REGIONAL REVIEW FINDING

Name of Proposal: Palmetto Site (DRI #3020)
Submitting Local Government: City of Palmetto

<u>Description</u>: A Development of Regional Impact (DRI) review for a proposed warehouse development of approximately 615,600 SF. The 57.41-acre site is located within the City of Palmetto along the south side of Roosevelt Highway (US 29/SR 14), east of Phipps Road, west of Bowen Road, and north of Johnson Road. The proposed site plan shows one driveway connecting to the east on Bowen Road. The review is expedited under GRTA rules for Limited Trip Generation because it is expected to generate more than 1,000 trips but no more than 3,000 trips. The local trigger for this review is a height variance. Expected buildout is 2021.

PALMETTO SITE DRI #3020 City of Palmetto Natural Resources Group Review Comments

DRI SITE PLAN

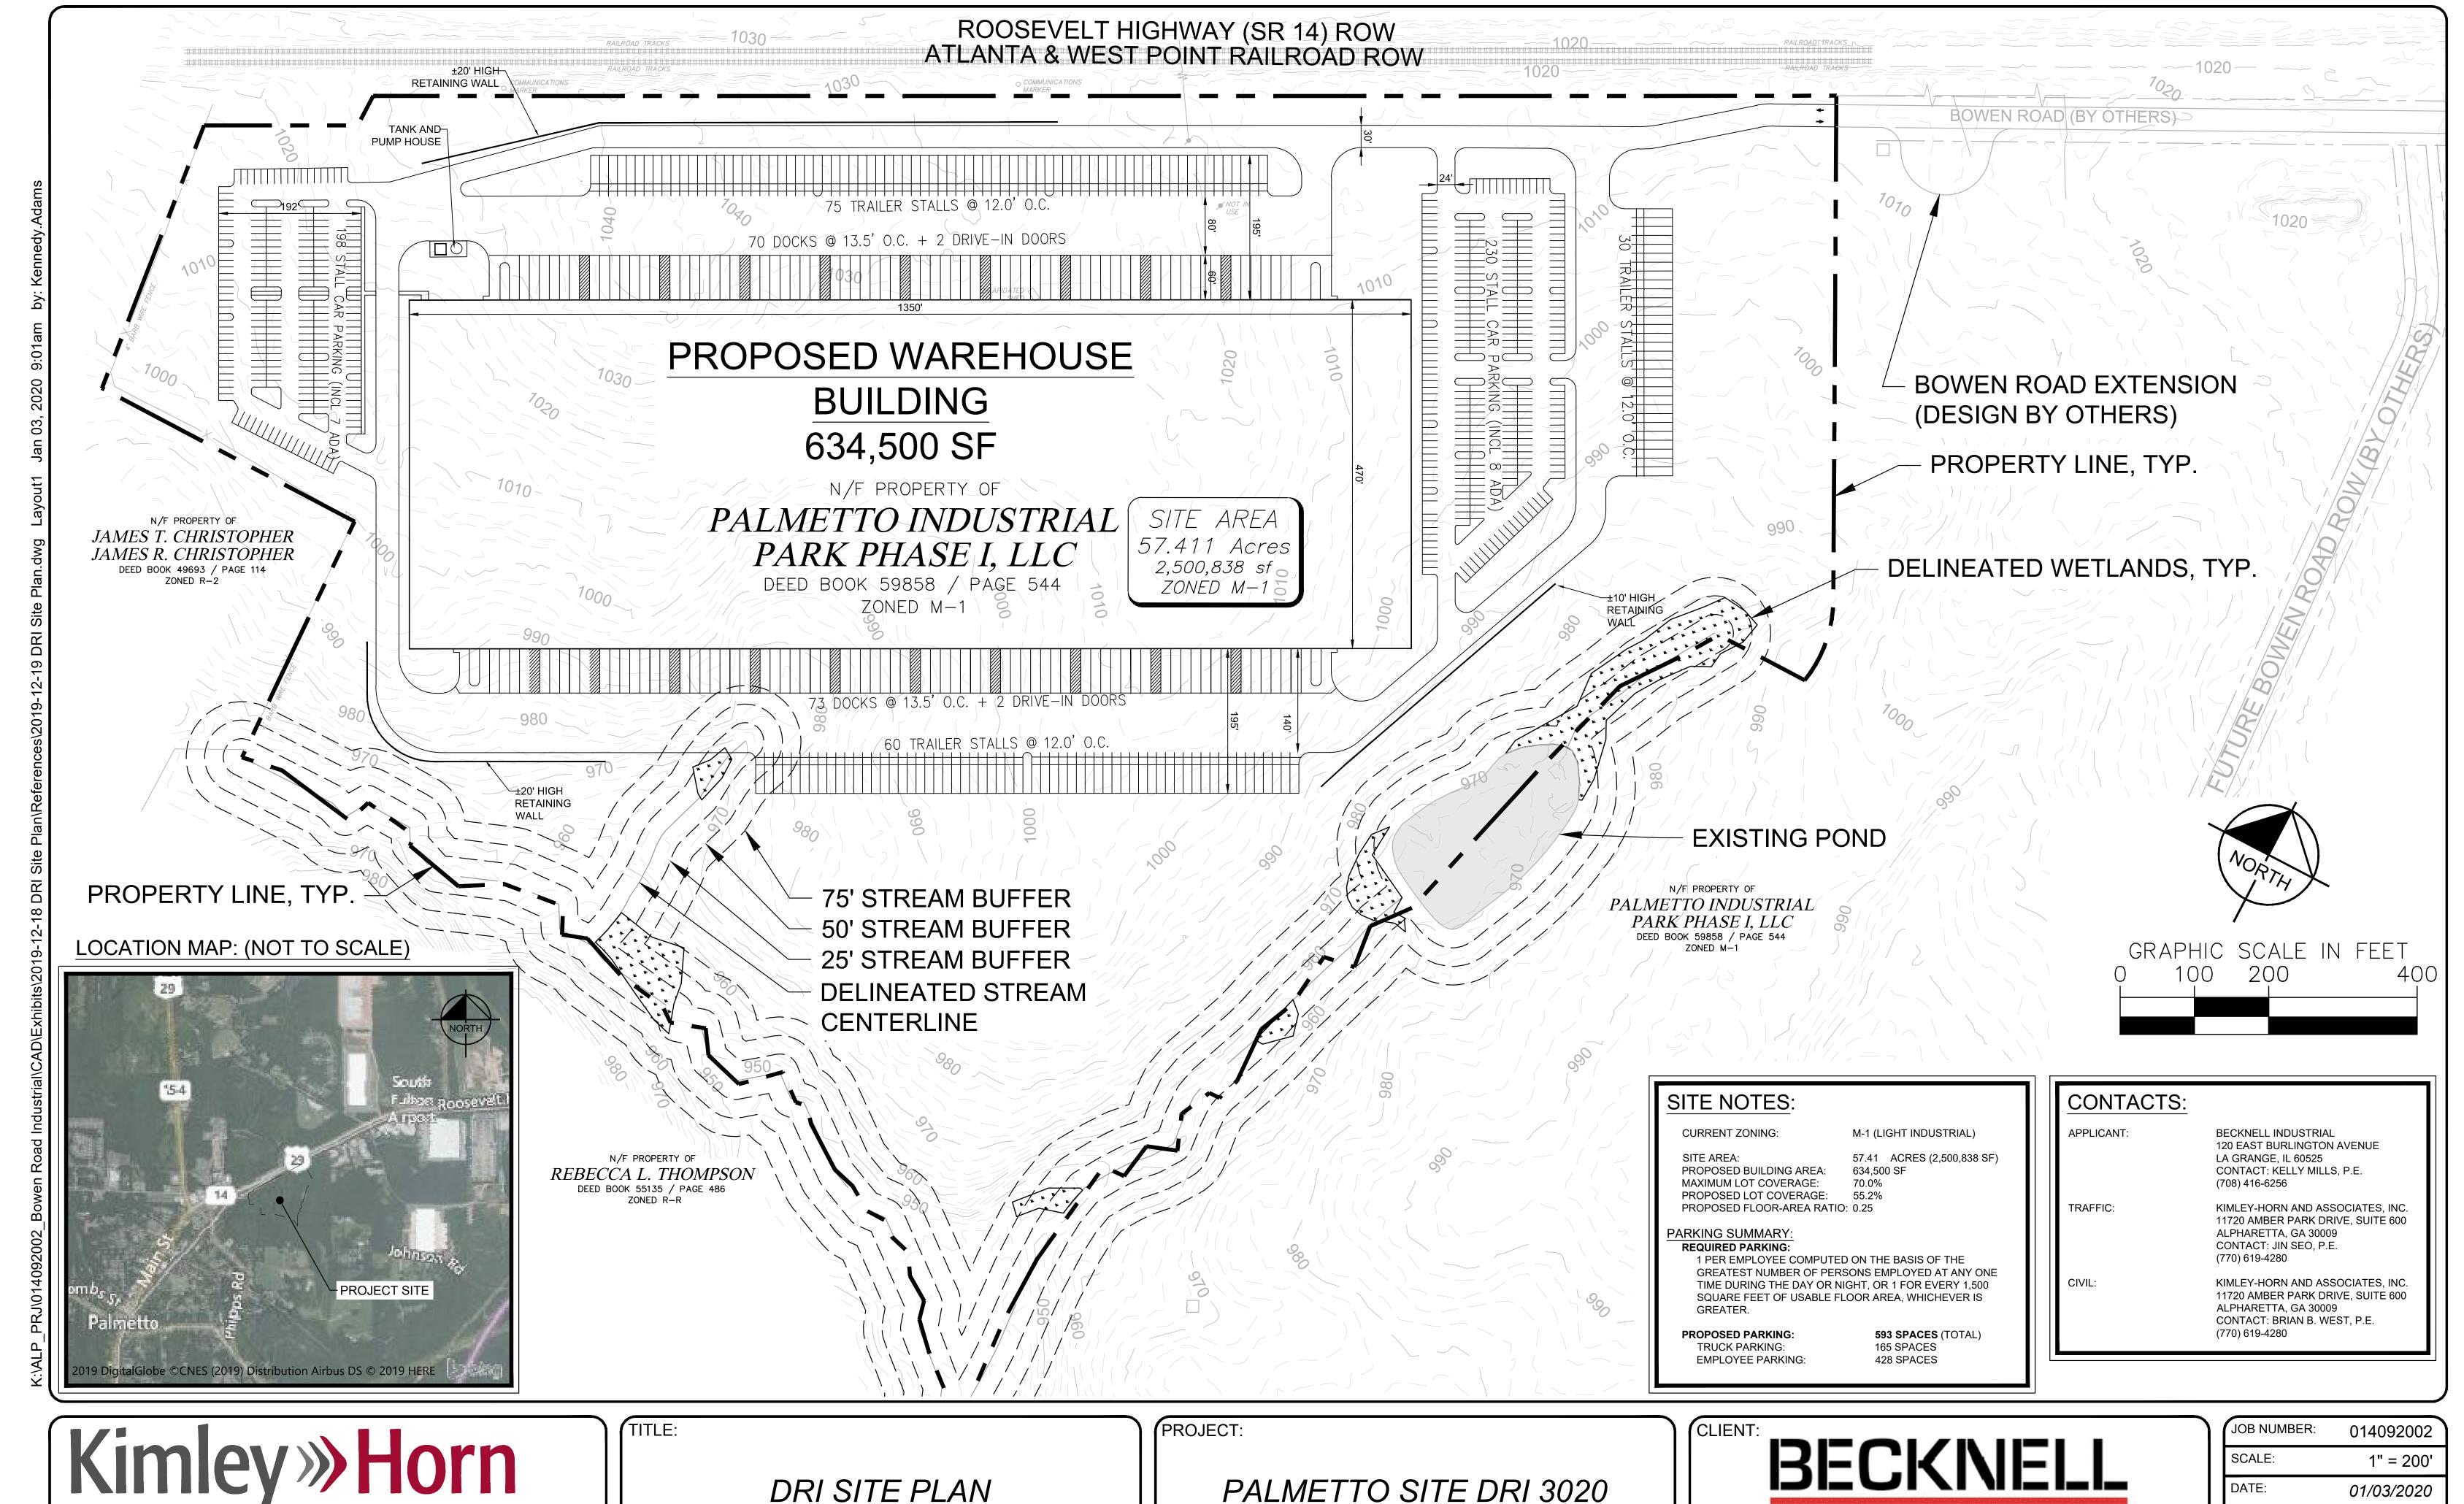
As stated above, the submitted site plan shows the mapped Shoal Creek along the southwestern boundary of the project property as well as two unmapped tributaries to Shoal Creek. The State 25-foot Sediment and Erosion Control Buffer as well as the 50-foot buffer and 75-foot impervious setback required by both the Part 5 Water Supply Watershed Minimum Criteria and the City of Palmetto's stream buffer ordinance are shown on all three streams on the site plan. A portion of the proposed structure and trailer parking area is shown intruding on the headwaters of the small tributary running into the property, which may require variances for the City and State buffers. No other intrusions are shown. Any other waters of the state that may be on the property will also be subject to the State Sediment and Erosion Control Buffer.

No No
YES (identify the roadways and existing/proposed access points)
The site plan identifies one access point on Bowen Road.

NOT APPLICABLE (the nature of the development or adjacent parcels does not lend itself to interparcel roadway connections)
	Access to adjacent parcels are provided through Bowen Road, a local road.
